0	1-20-77	Issued for use.						
CHG.	DATE	DESCRIPTION	APPRD.	CHG.	DATE	DESCRIPTION	APPRD.	
APPROVED			RLH	RCS	PA	CT		
BY			PIPING - DATA SHEET				SUPERSEDES	
DSGN.			ARC WELDING PROCEDURE -				SUPERSEDED BY	
DR.			ALL STRESS LEVELS				SHEET No. 1	SHEETS
CH.			GAS STANDARD				DRAWING NUMBER	CHANGE
O.K.			PACIFIC GAS AND ELECTRIC COMPANY				086432	0
DATE	SCALE							
9-13-76

FOR ARC WELDING NATURAL GAS PIPELINES

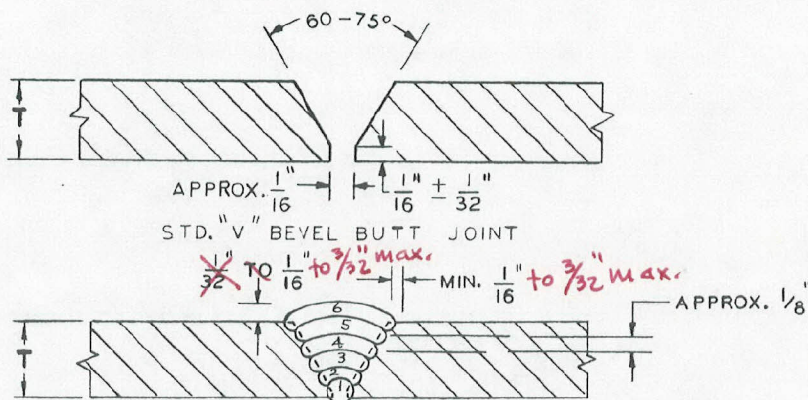
WELD LAYER	METHOD		ELECTRODE		RECOMMENDED	
	HORIZONTAL FIXED POSITION	* VERTICAL FIXED POSITION	CLASS	SIZE	AMPS	VOLTS
FIRST PASS	DOWNHILL	BEAD	NOTE 2	ALL	<del>150-190</del> 100-170	26-28
HOT PASS (SEE NOTE 4)	DOWNHILL	BEAD	NOTE 2	1/8" OR 5/32"	<del>160-200</del> 120-160	<del>45-50</del> 24-28
FILLER PASSES	DOWNHILL	BEAD	NOTE 2	ALL	<del>140-200</del> 180	<del>24-26</del> 28
COVER PASS	DOWNHILL	BEAD	NOTE 2	ALL	<del>140-200</del> 180	<del>24-26</del> 28

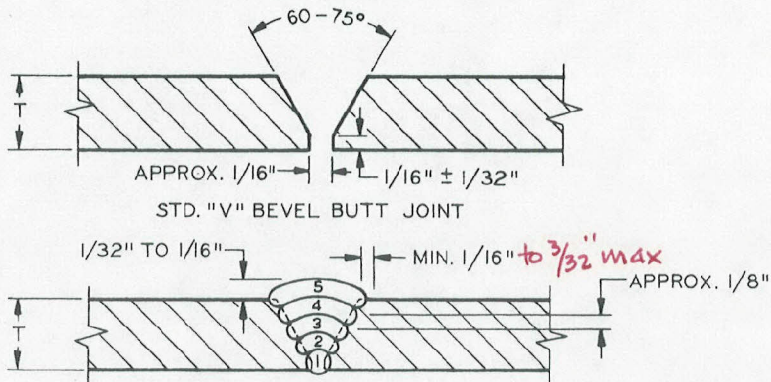
WELD LAYER	METHOD		ELECTRODE		RECOMMENDED	
	HORIZONTAL FIXED POSITION	* VERTICAL FIXED POSITION	CLASS	SIZE	AMPS	VOLTS
FIRST PASS	DOWNHILL	BEAD	SEE NOTE 5	ALL	<del>150-190</del> 100-170	26-28
HOT PASS <input checked="" type="checkbox"/>	DOWNHILL	BEAD	SEE NOTE 5	1/8" OR 5/32"	160-200 120-160	45-50 24-28
FILLER PASSES	UPHILL	BEAD	E 7016 OR E 7018	1/8"	<del>150-190</del> 100-150	<del>35-40</del> 22-25
COVER PASS	UPHILL	BEAD	E 7016 OR E 7018	1/8"	<del>150-190</del> 100-150	<del>35-40</del> 22-25

- LOW HYDROGEN <sup>electrode</sup> WELDING IS RECOMMENDED ONLY FOR HIGH YIELD, HEAVY WALL PIPE FOR STATION PIPING, RIVER CROSSINGS OR OTHER LOCATIONS WHERE VIBRATION OR EXTERNAL LOADING MAY OCCUR. IT PRODUCES A MORE DUCTILE HIGH STRENGTH WELD WHICH GIVES SUPERIOR NOTCH STRENGTH. HOWEVER, THE LOW HYDROGEN WELDING PROCESS IS MORE TIME CONSUMING THAN THE CONVENTIONAL PROCESS, <sup>cellulose electrode</sup> AND SHOULD BE USED ONLY WHERE SPECIFIED BY THE PROJECT ENGINEER. CONTACT THE GAS SYSTEM DESIGN DEPT. IF MORE INFORMATION IS REQUIRED.

*electrode (E-7016 or E-7018)*

*cellulose electrode (E-6010 or E-7010)*
